City of Plymouth Planning Commission

Regular Meeting Agenda

**Site Plan Review
For
Plymouth, Michigan**

Subject: PCA Building Expansion – Site Plan Review

PROPOSED SITE PLAN

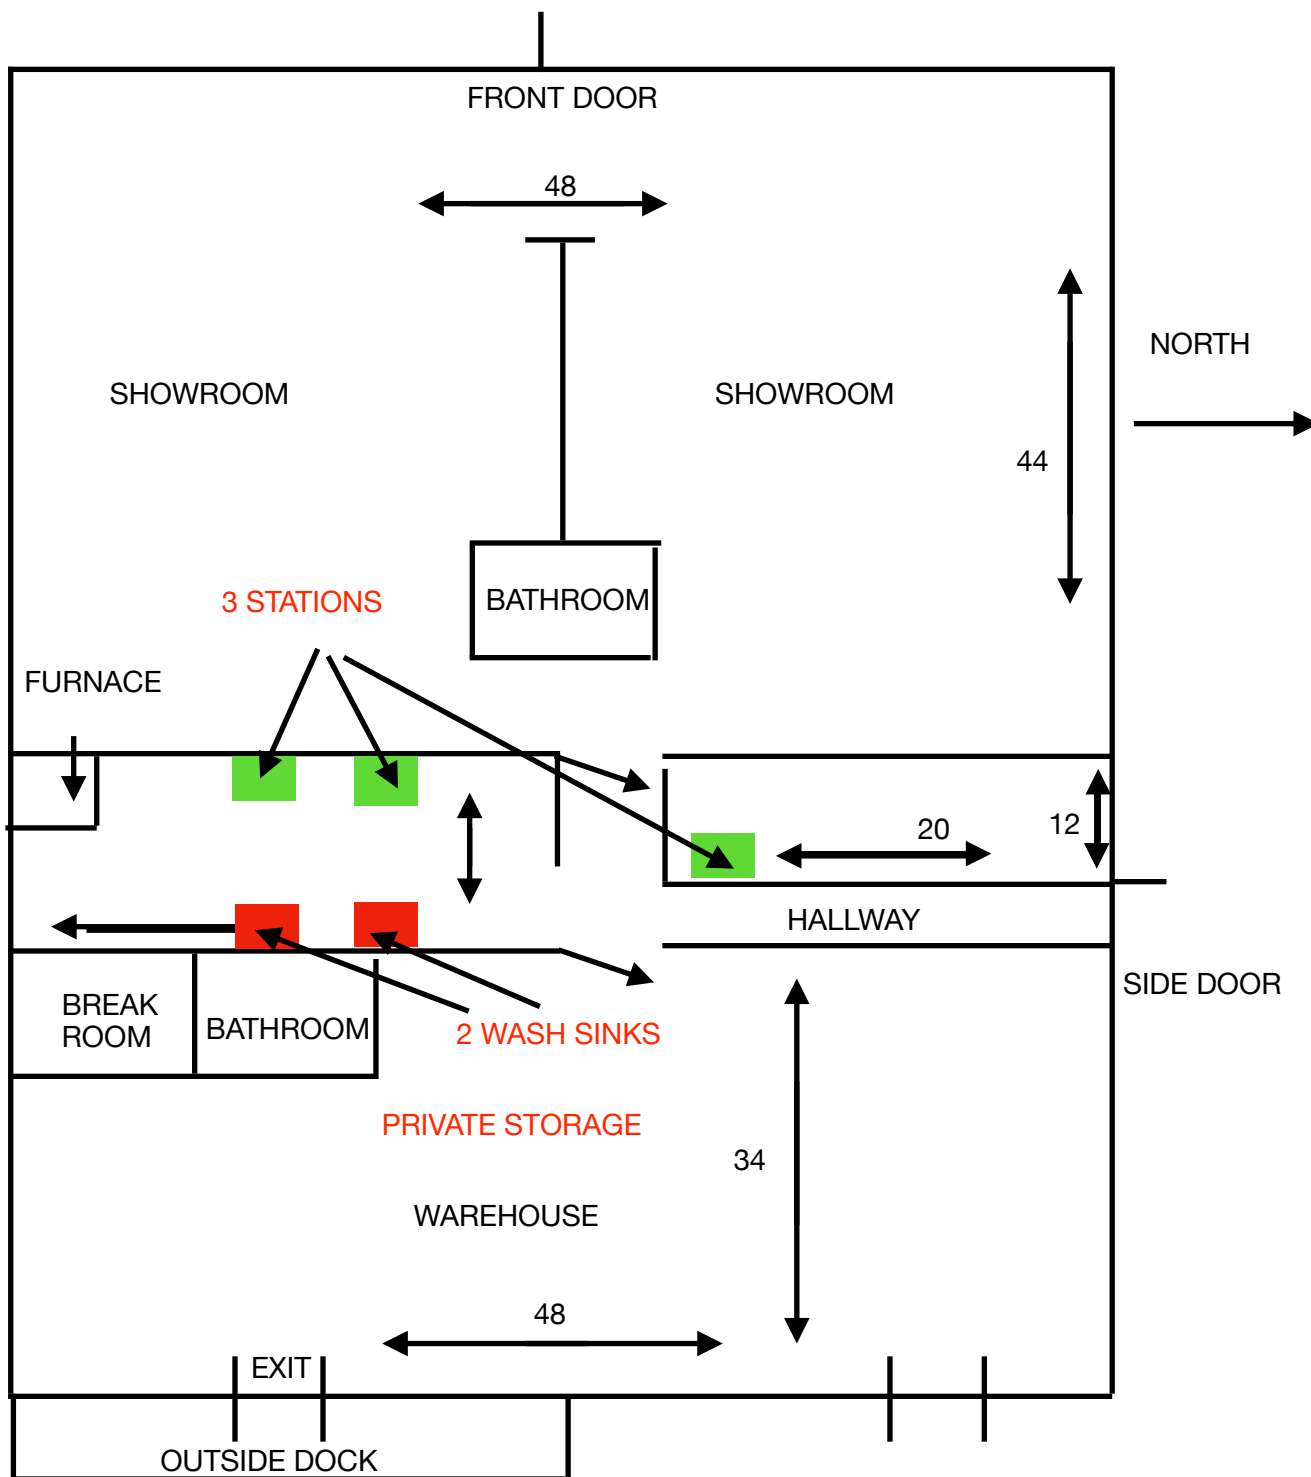
CWA Comments: *A floor plan (labeled "Proposed Site Plan") has been provided, showing the estimated size of the various interior uses in the building. The showroom for antiques will be approximately 2,100 s.f., salon area approximately 1,000 s.f., and the storage area approximately 1,630 s.f. (Note: We*

also referred to the building information on the City's online property website; the exterior measurements of the building are 50' x 100' or 5,000 s.f. The applicant's drawing shows the interior space at approximately 4,800 s.f.)

The rear of the building has a loading dock, indicating where trucks would park to load/unload antiques. The applicant should provide the size of trucks that will be using the loading dock.

Sheet No.
C-300

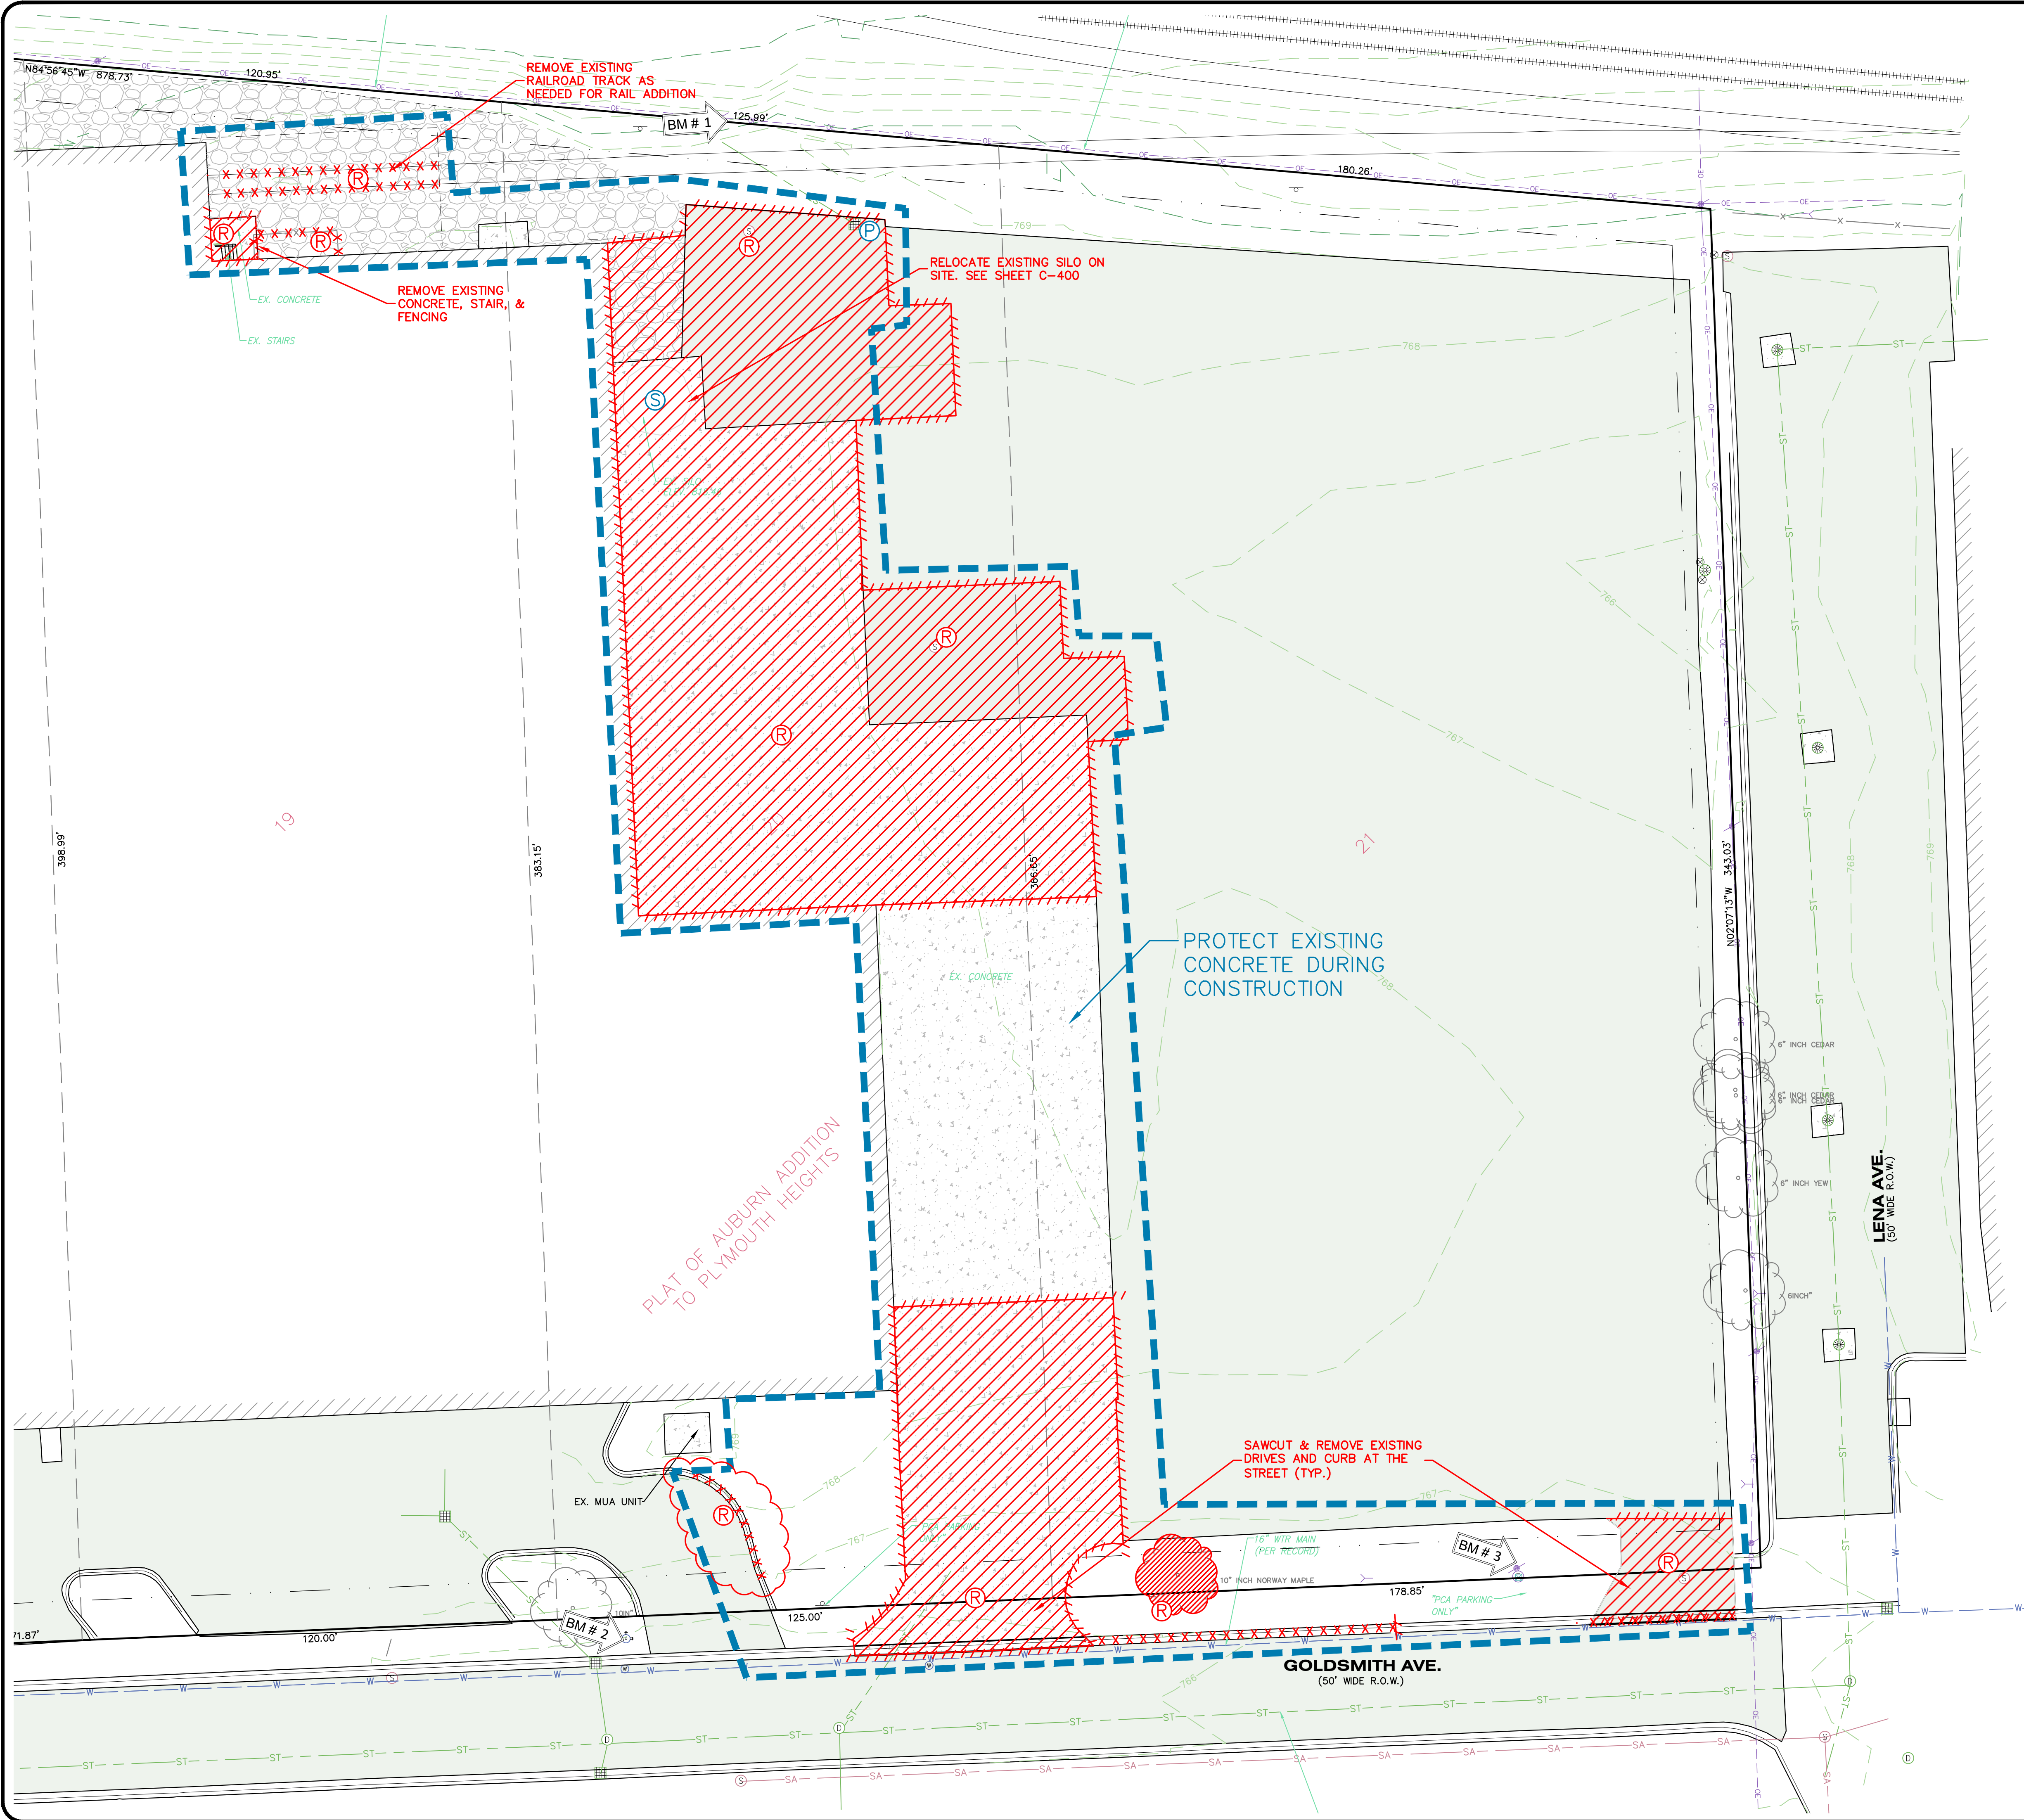
1. The site plans that have been submitted do not propose any storm sewer improvements or storm water detention improvements.
2. We observe that most storm water runoff appears to drain toward the east property line, where one existing catch basin is located to drain water from the truck parking lot.

3. The outlet for this catch basin along the east side of the parking lot is not clearly delineated on the plans. From our field visit, it appears that it may drain east to the existing storm sewer in the Lena right-of-way. This should be confirmed prior to re-submittal for engineering approval.

4. Due to the significant impervious area that exists on the east side of the existing building, we recommend that storm water detention be required and included as part of this site plan approval. The City of Plymouth currently follows the Wayne County Storm Water Ordinance. Please note that we are not suggesting that storm water detention be provided for the entire property at this time, only for the parking lot area east of the building and the new building additions.

Date	09/10/22
SME Project No.	89845.00
Project Manager:	J. EVANS
Designer:	A. FRAZIER
CADD:	N. RICHMOND
Checked By:	T. STEWART
Reviewed By:	T. STEWART
Sheet No.	C-500

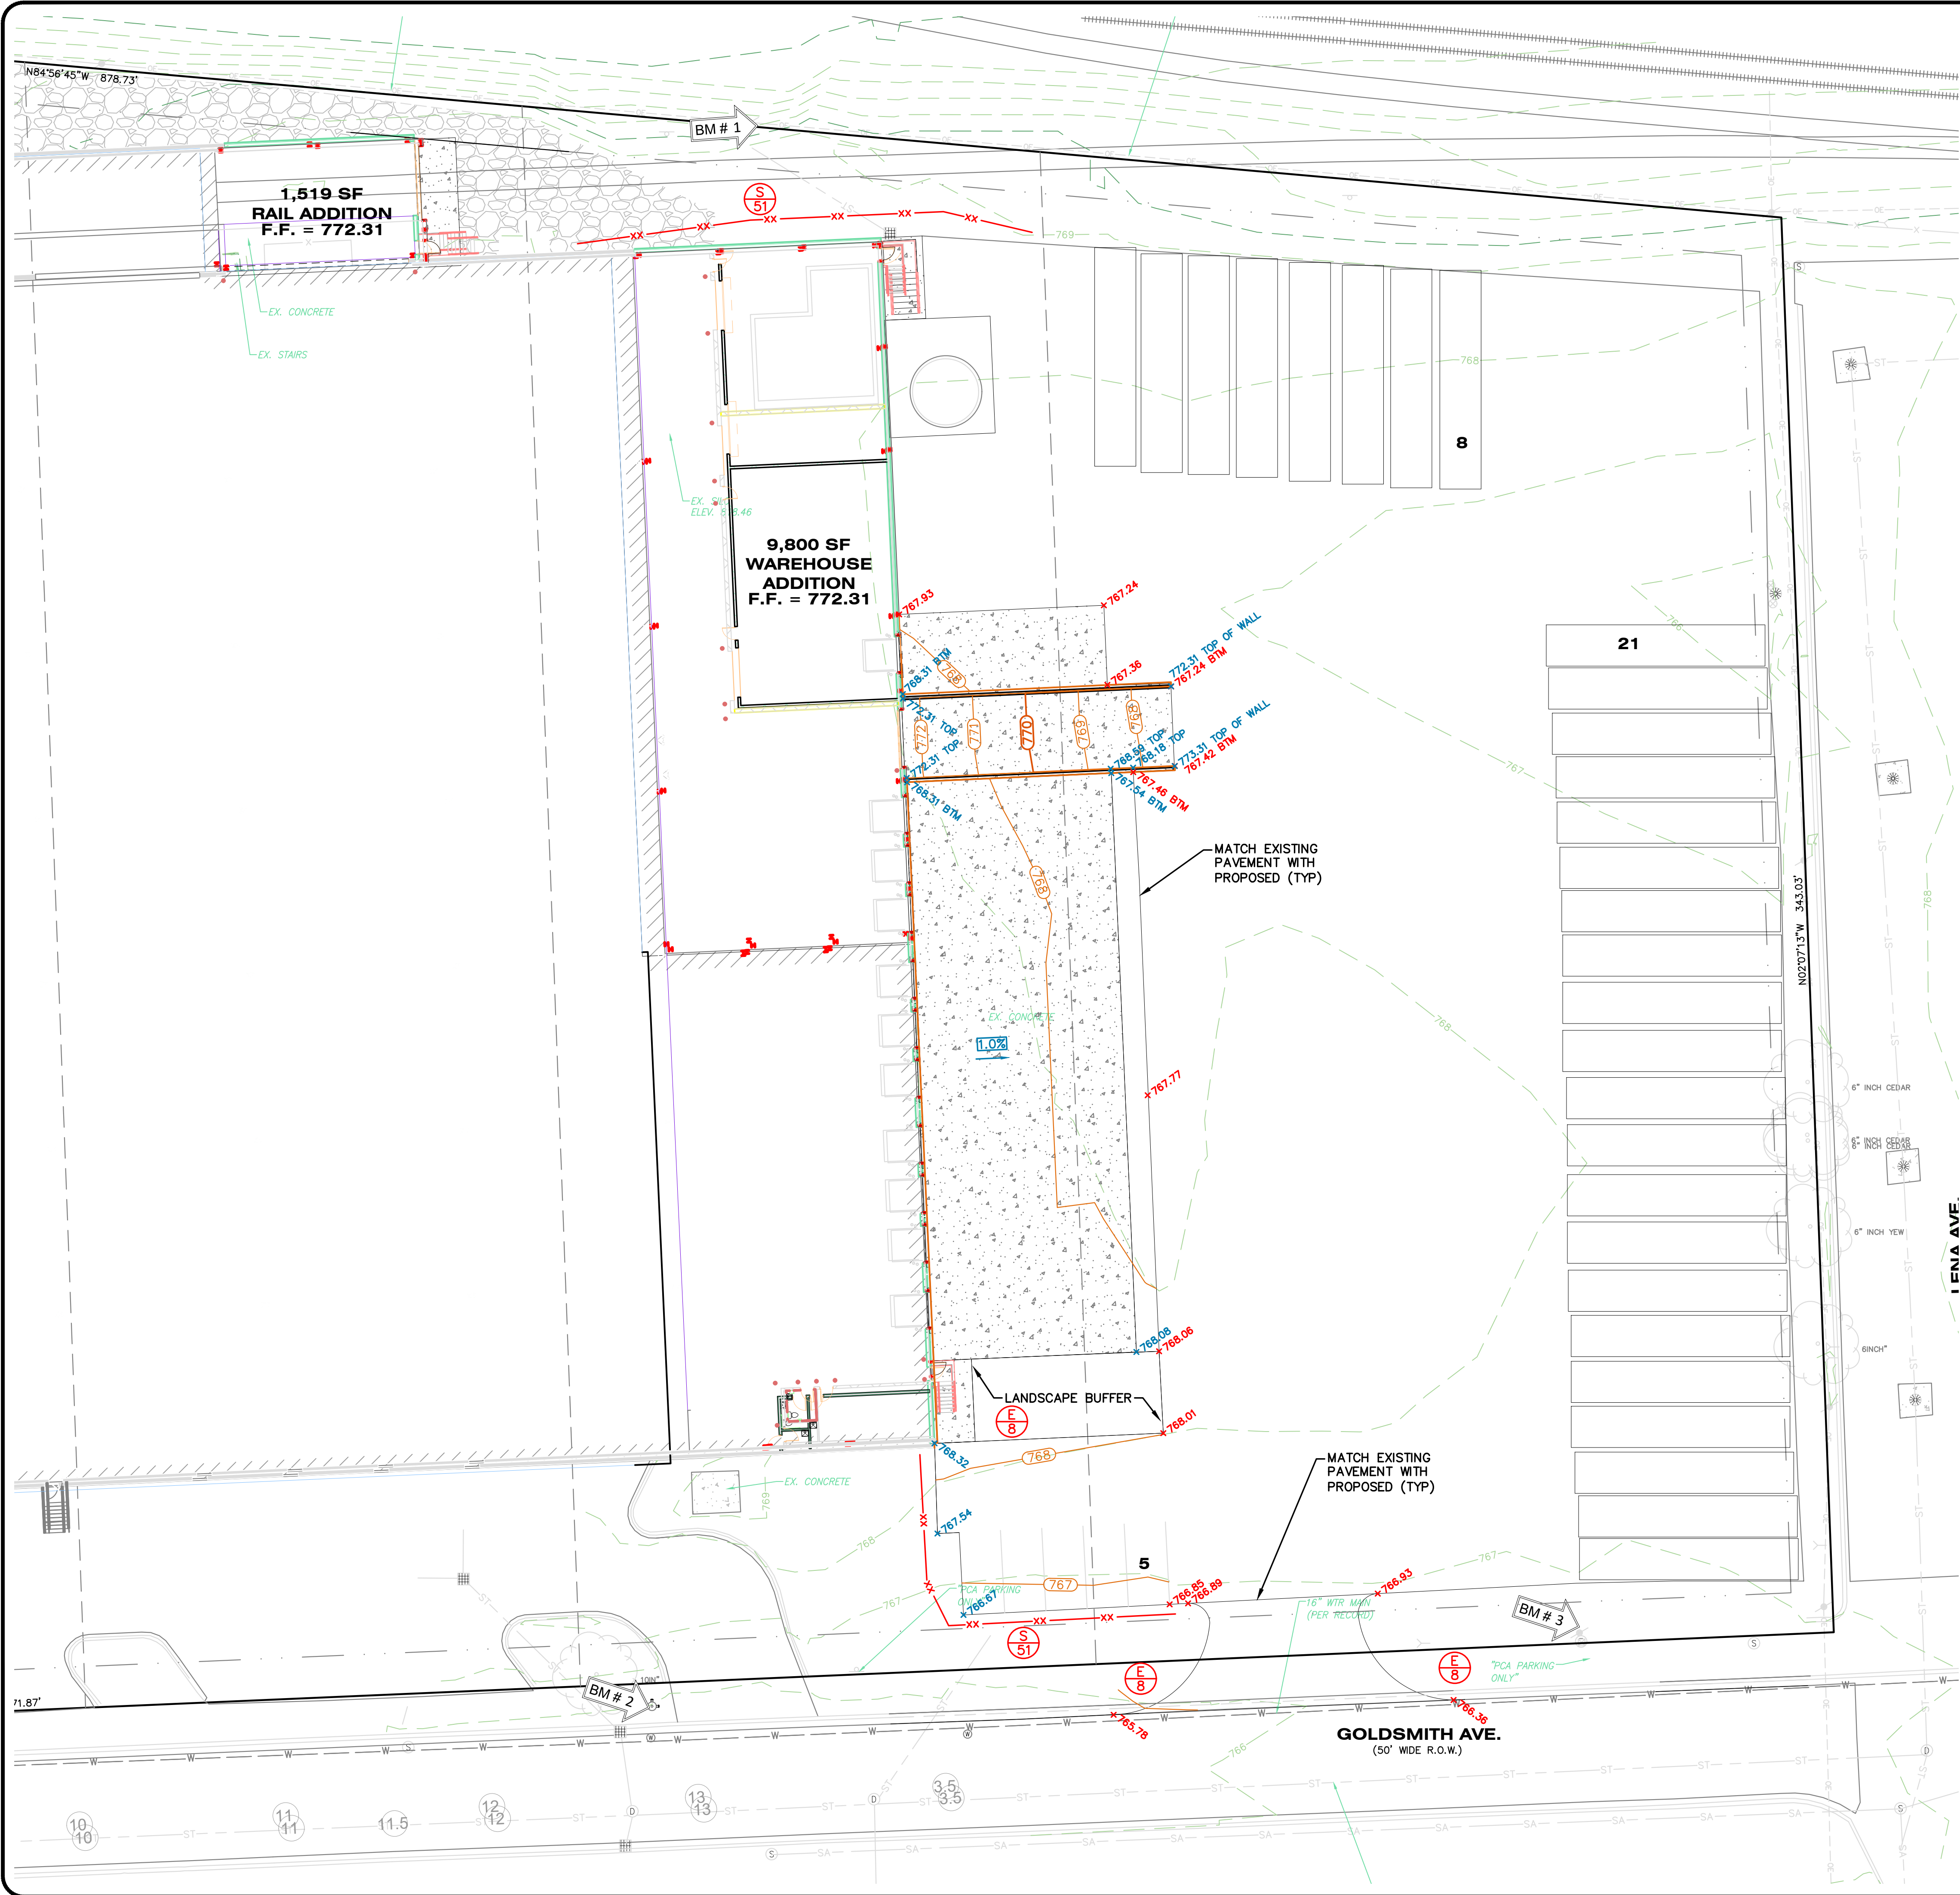
Turning movements of semi-trailer trucks are shown on Sheet C-500. Given the turning movements indicated on this sheet, it appears that the lot provides adequate space for a semi-trailer truck to back into the loading docks, and maneuver out of the docks back to Goldsmith Ave.
